# 38748 Minnesota Pollution Control Agency Request for Comments

RESPONSE TO- Request for Comments on Possible Amendment to Rules Governing Drainage Holes  
Beneath Sewage Tank Operating Levels, MN Rules 7080, Revisor's ID Number R-04773

Del Zotto Products of Minnesota				
1900 County Road #1, Wrenshall, MN 55797 218-384-3066 Fax 218-384-3088				
DRAWING DESCRIPTION				
DZ-2500-S-WZ				
Septic Tank W/Weep Hole				
SIZE	DWG BY	REV		
A	DLS	D		
File Name		SCALE	DATE	SHEET
P2DZ2500SHPCADD		1:48	09/09/21	1 OF 1

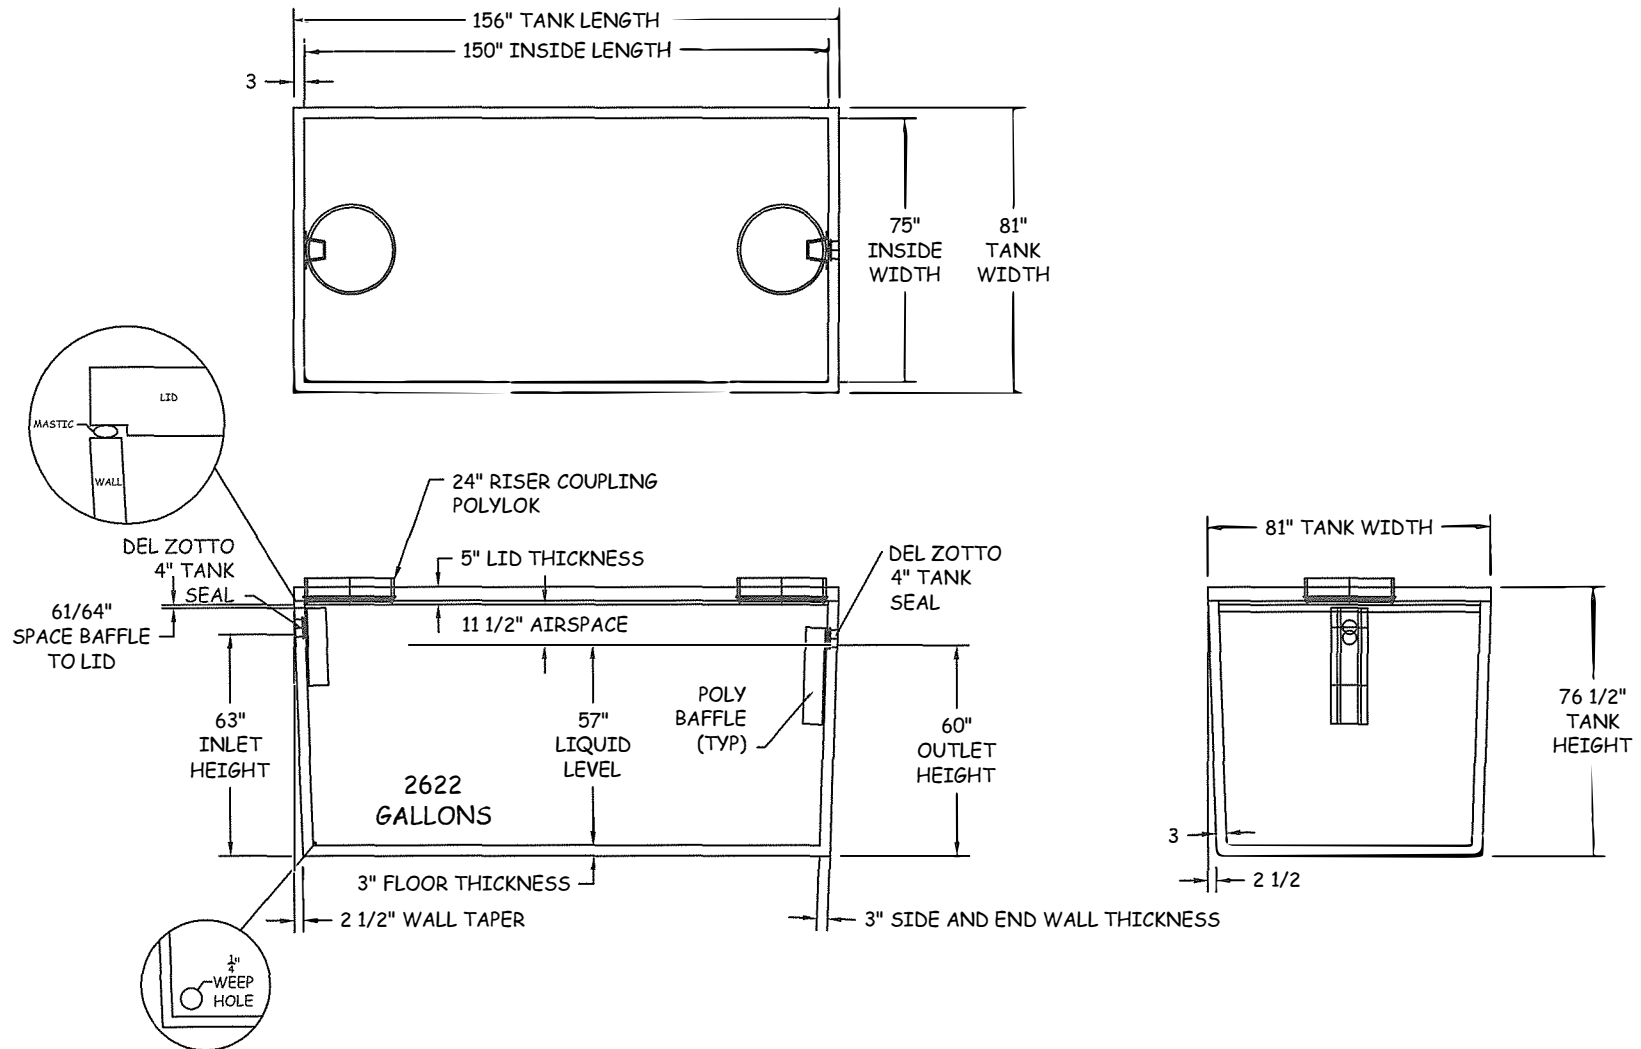
DZ-2500-\_\_\_\_\_ - WZ The "WZ" or "Winterization" added to end of the tank's model number indicates that the tank has additional drainage holes for that model.

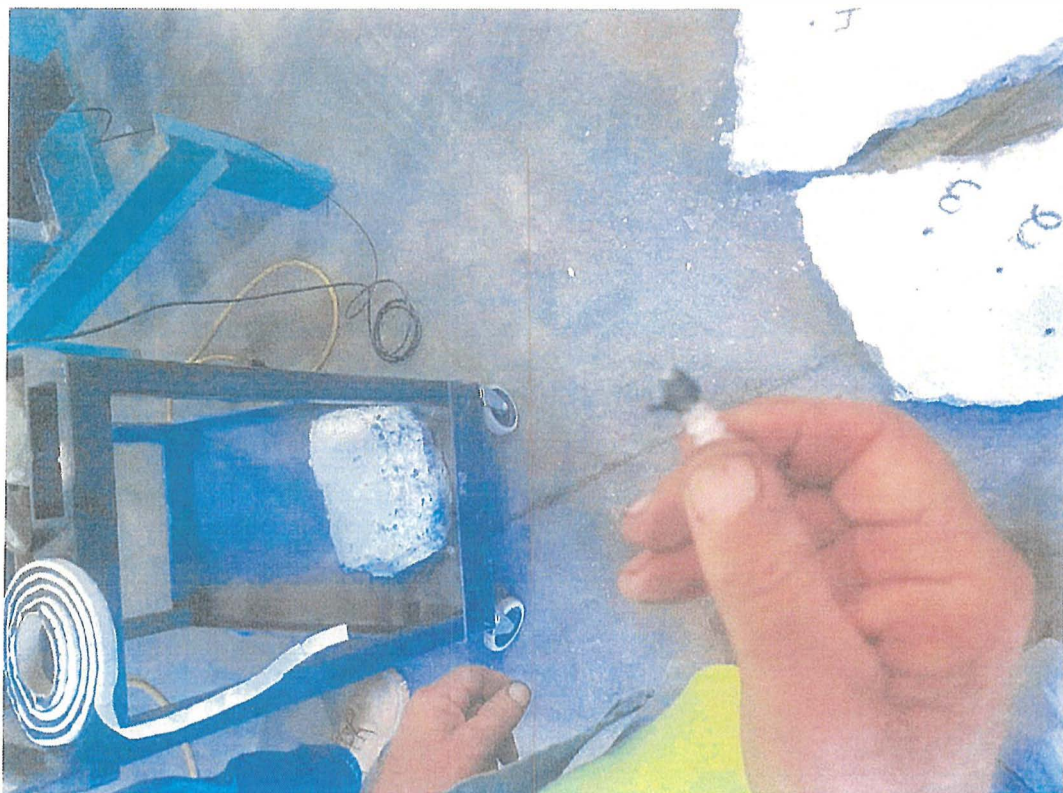
This picture shows the mastic on the plug to provide additional sealing in addition to the plug. It should be noted that the covers of all the tanks set in place via gravity with only a mastic seal and it functions well in the field.

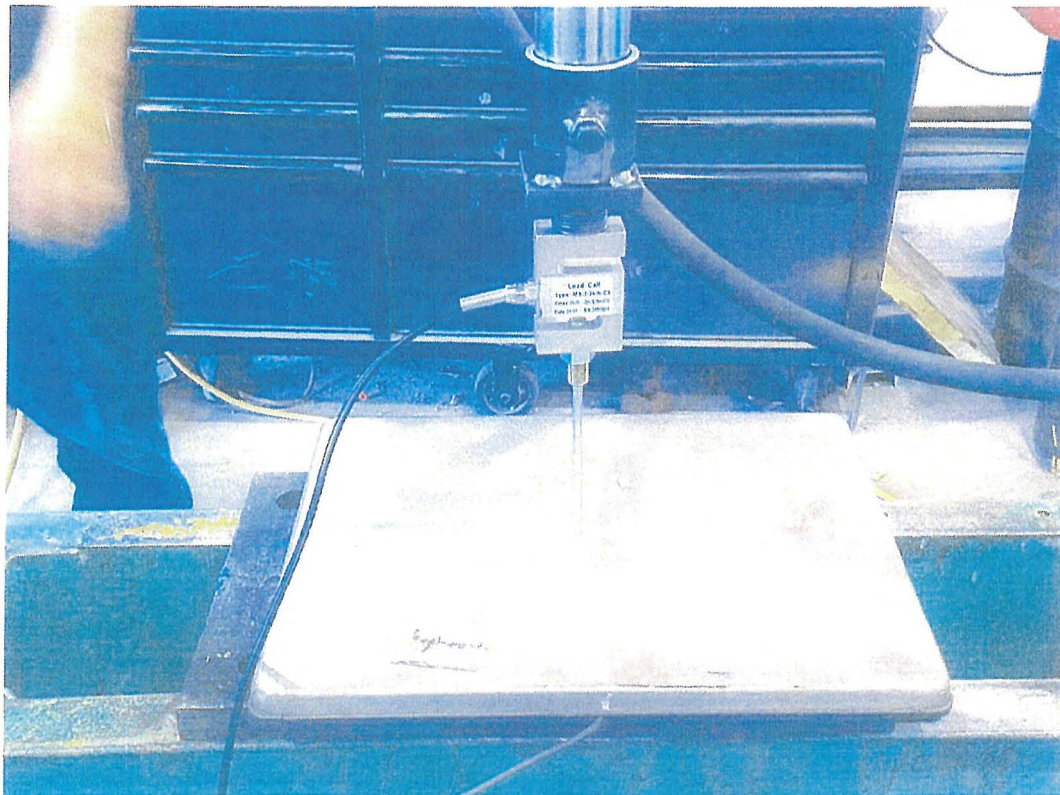
Below is a picture of the load cell that was used to measure the dislodging force required to unseat the plug.
